SUBJECT: DRESDEN NUCLEAR POWER STATION, UNITS 2 AND 3 – STAFF  
ASSESSMENT OF RESPONSE TO 10 CFR 50.54(f) INFORMATION  
REQUEST – FLOOD-CAUSING MECHANISM REEVALUATION (TAC  
NOS. MF1795 AND MF1796)

STAFF ASSESSMENT BY THE OFFICE OF NUCLEAR REACTOR REGULATION  
RELATED TO FLOODING HAZARD REEVALUATION REPORT  
NEAR-TERM TASK FORCE RECOMMENDATION 2.1  
RELATED TO THE FUKUSHIMA DAI-ICHI NUCLEAR POWER PLANT ACCIDENT  
DRESDEN NUCLEAR POWER STATION, UNITS 2 AND 3  
DOCKET NOS. 50-237 AND 50-249

**Figure 3.2.6-1 Locations of Critical Doors and Bays**

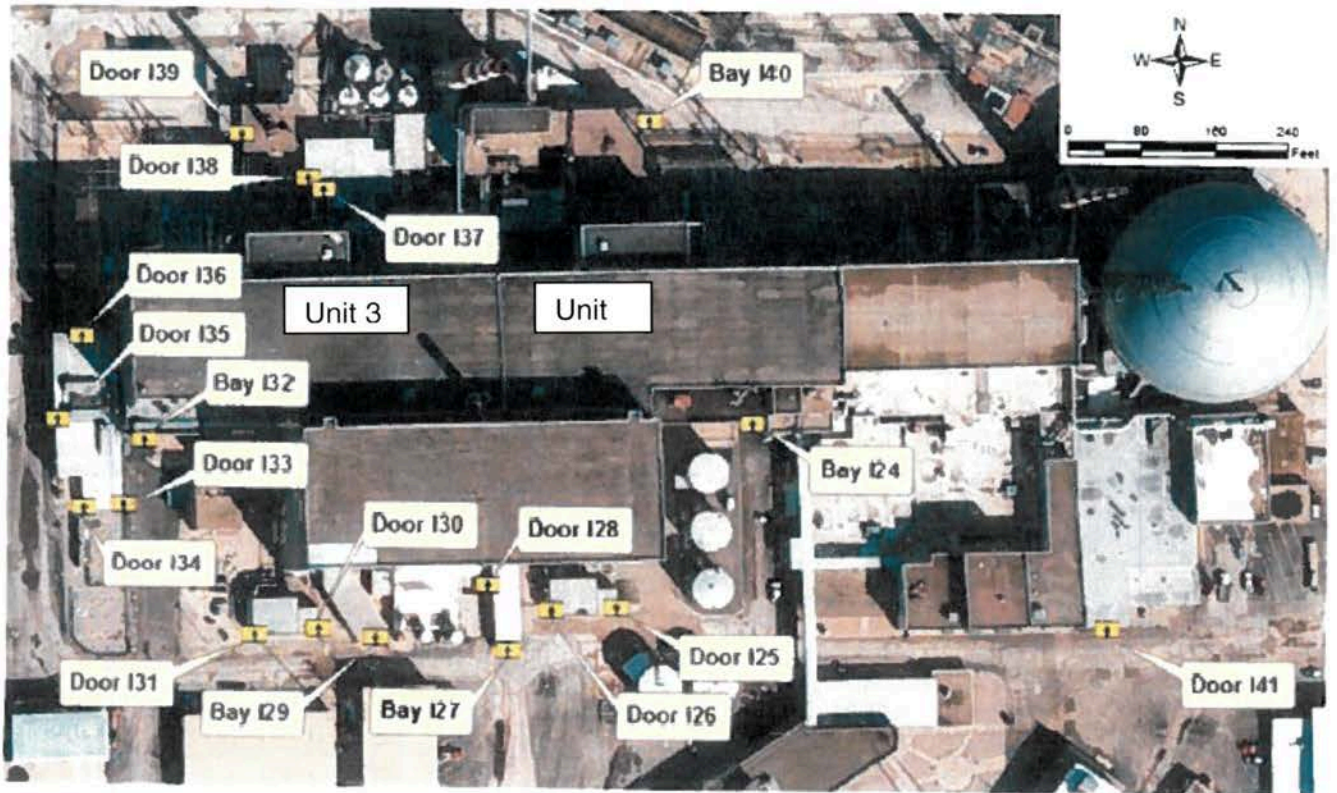
The staff performed a comparison of the two analyses to determine the significance of the site-specific PMP analysis, and whether a more detailed review of the analysis would be required. The staff compared the maximum 1-hour, 1-square mile precipitation between the two analyses, and the resultant maximum water surface elevation. Table 3.2.6-1 presents this comparison, including the percentage change from the HMR-based precipitation to the site-specific precipitation. The staff also compared the flood depths at the critical doors and bays, presented in Table 3.2.6-2, with a reference Figure 3.2.6-1, which is derived from licensee's Figure 4 from the LIP analysis report (Exelon, 2013b).

The staff noted that the site-specific PMP reduced the depth at critical doors and bays by a maximum of 0.2 ft (0.06 m) at Bay 124. The staff considered the difference in effective in flood depths between the site-specific PMP and the HMR-based PMP water depths to be small. For comparison, the typical height of a sandbag is 0.3 ft (0.1 m) (see *Sandbagging Techniques* (USACE-NWD, 2004)). Therefore, the staff did not review site-specific PMP methodology associated with the RAI response since the revised rainfall (model input) effectively produces the same water depths (model output) at the site.
